■ FRAME

The frame is basically the same ladder type used in the previous model. The shape of the various areas of the frame has been revised in order to realize excellent collision safety performance and to improve riding comfort.

A-A Cross Section

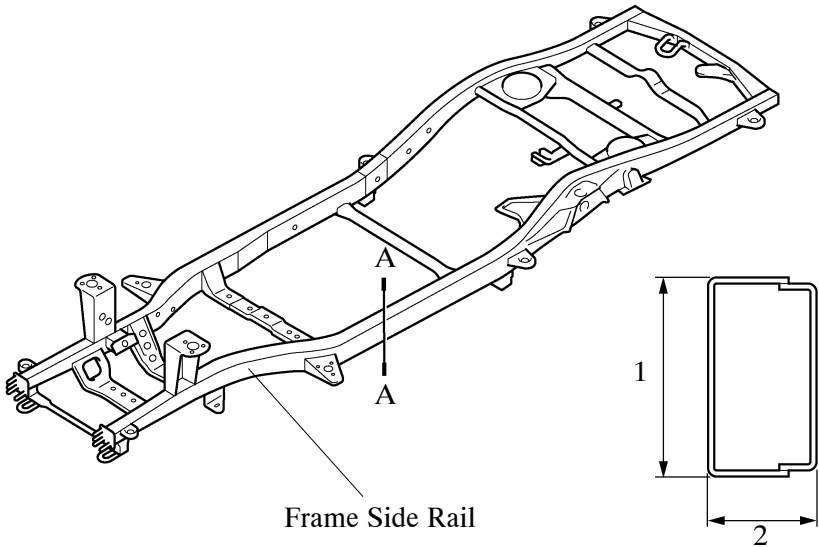
- The cross section area of the frame side rail has been enlarged in order to realize excellent frame's rigidity and joining rigidity of the suspension system. As a result, the vehicle's riding comfort has been improved.

Model			New	Previous
Item				
1	Height	mm (in.)	160 (6.3)	140 (5.5)
2	Width	mm (in.)	85 (3.3)	70 (2.8)
